Site Technical Query - Form

TQ Number:		Project:	
CW2144960		-A010-	0060
Oyu Tolgoi Underground Project			
A. To be completed by or on behalf of the Contractor			
Contractor/Sub-Contractor Name:	MCS International	Date Response	28/01/2022
Contract Title:	Booster Fan installations	Plant Area &	1693
Contract No.	CW2144960	Contractor TQ Number:	BF-0415-TQ-0060
Discipline Codes (Mandatory) D1 (CSA) - <input type="checkbox"/> D2 (MP) - <input checked="" type="checkbox"/> D3 (E&I) - <input type="checkbox"/> D4 (Other) - <input type="checkbox"/>			
Description of Technical Query (List affected drawings and specifications): HVAC condenser 1693-SRM-2001-AHU-CNDA Line route E-room HVAC Condenser 1693-SRM-2001-AHU-CNDA unit will be installed on top of 1693-SRM-2001-AHU-CNDB unit as per TQ-0045 (attachment 1). Therefore, to determine the line connection route the gas and liquid pipes from the outdoor unit 1693-SRM-2001-AHU-CNDA to the indoor unit as per 1693-65-IOM-1500 page 77 (attachment 2).

Attachment 1

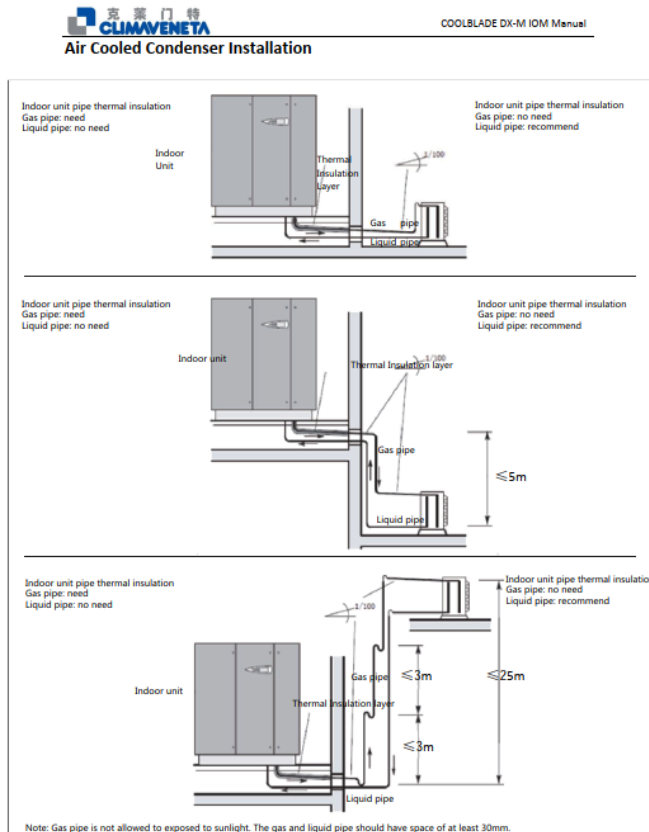
<input type="checkbox"/> Routine <input checked="" type="checkbox"/> Urgent Refer Technical Query instructions			
Proposed Action (List all attachments) The contractor is proposed the following action. <ol style="list-style-type: none"> The route of the gas and liquid pipe line is marked in red on attachment (attachment 3). All changes will be marked in redline. 			
Effect on cost (USD):	NO		
Effect on schedule (Days):	NO		
Effect on quality:	NO		
Requested by (Name):	Delgersuren.N	Position:	SMP Engineer
Signature:		Date: (dd/mm/yyyy)	26/01/2022

Proceed as **OPTION#2** with following comments:

- This TQ is accepted only for location of the condenser unit 1693-SRM-2001-AHU-CNDA.
- The Contractor shall be provided gas and liquid pipe route as per Manufacturer recommendation which shows Page-77 on 1693-65-IOM-1500. Prior to installation, separate TQ shall required and confirmed by Worley Reps.

- The Contractor shall be provided Mounting Detail of this relocated condenser unit. Prior to installation, separate TQ shall required and confirmed by Worley Reps.
- Changes shall be redlined on all relevant drawings.

1693-SRM-2001
PLAN

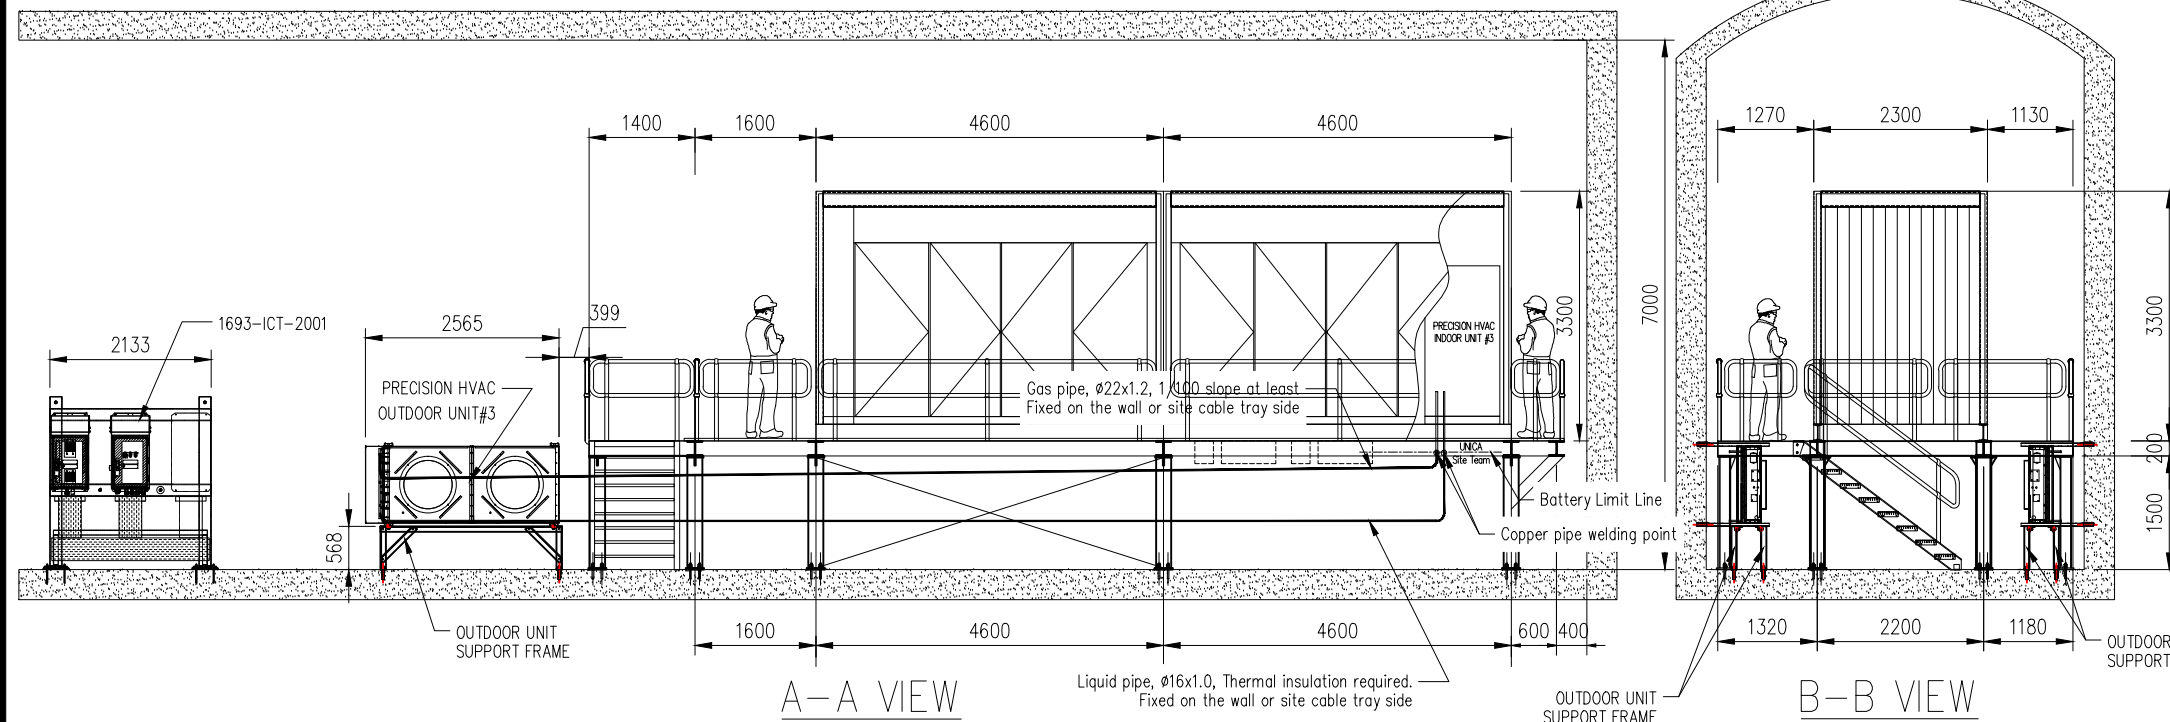
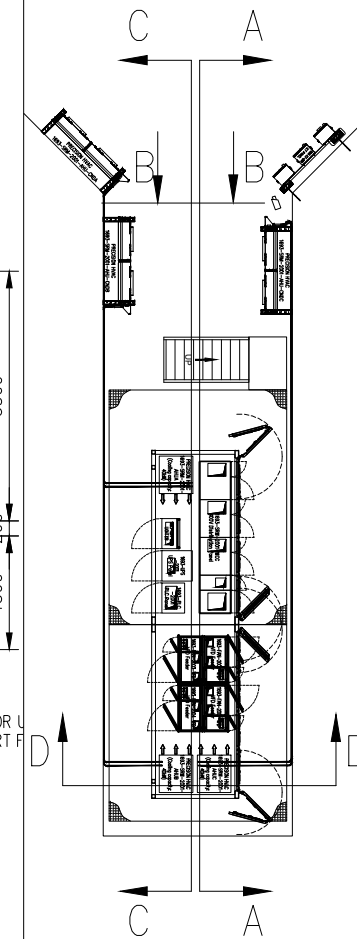
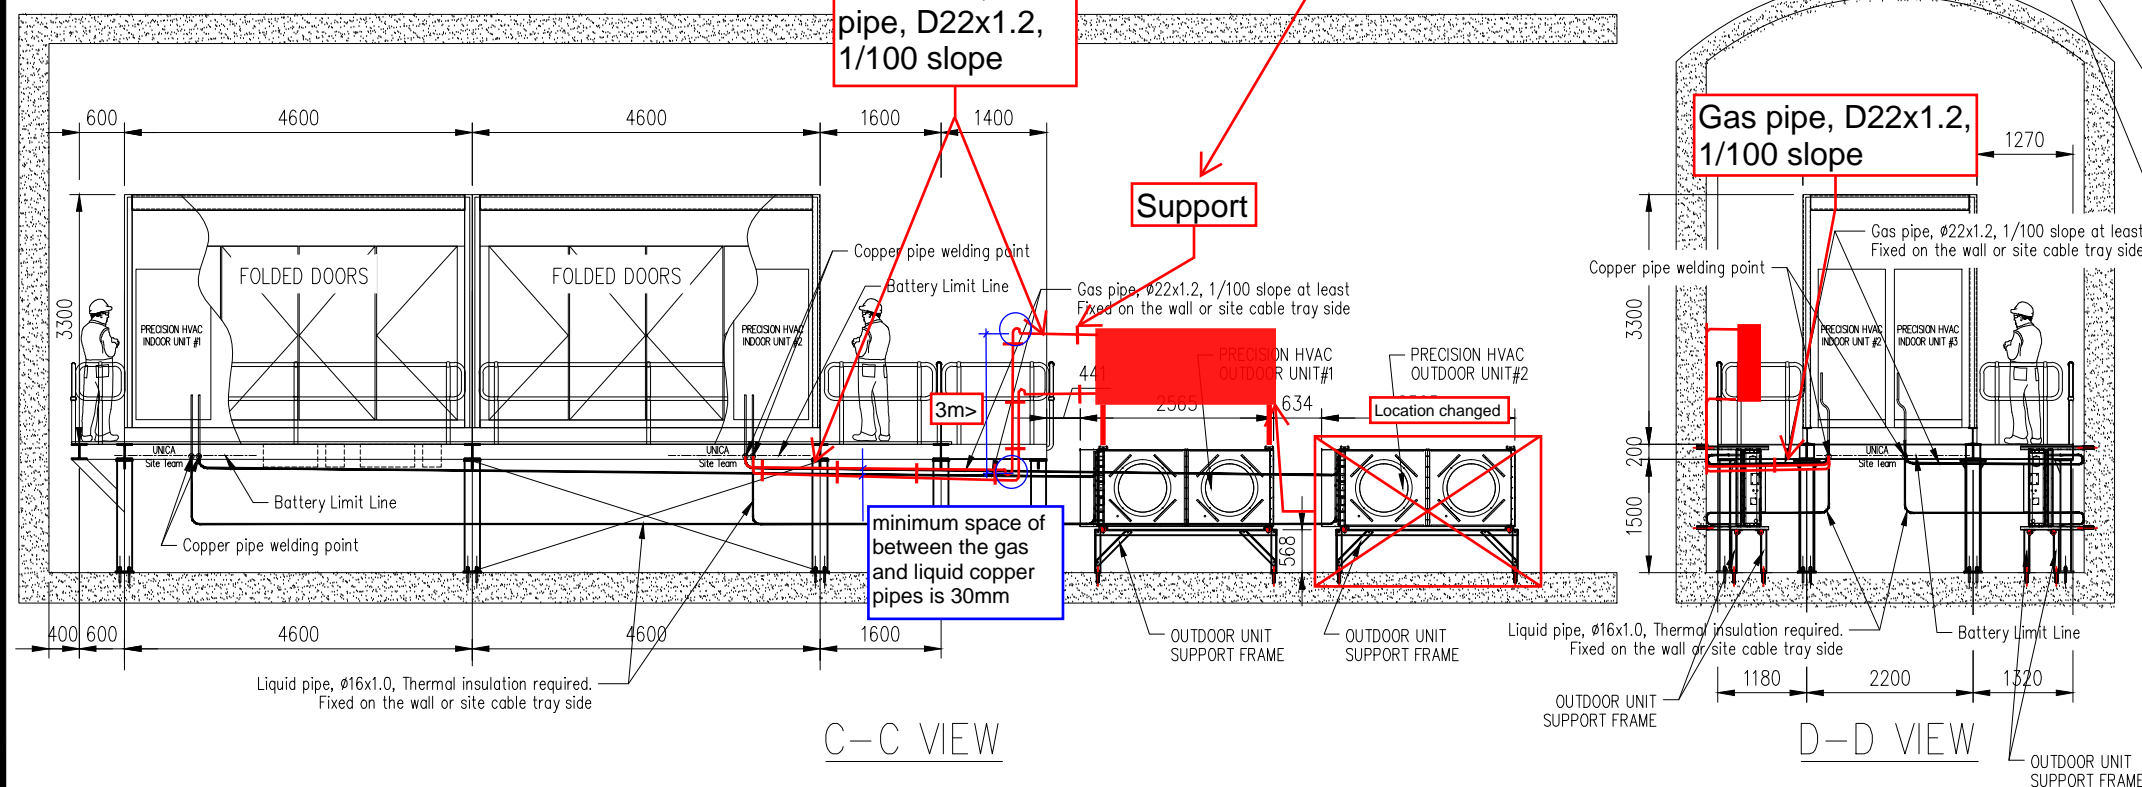
The pipes use PU insulation clips to fix on the wall or site cable tray side. the distance between 2 clips should be not more 1.5m, and the distance from the pipe end should be not more than 0.5m.
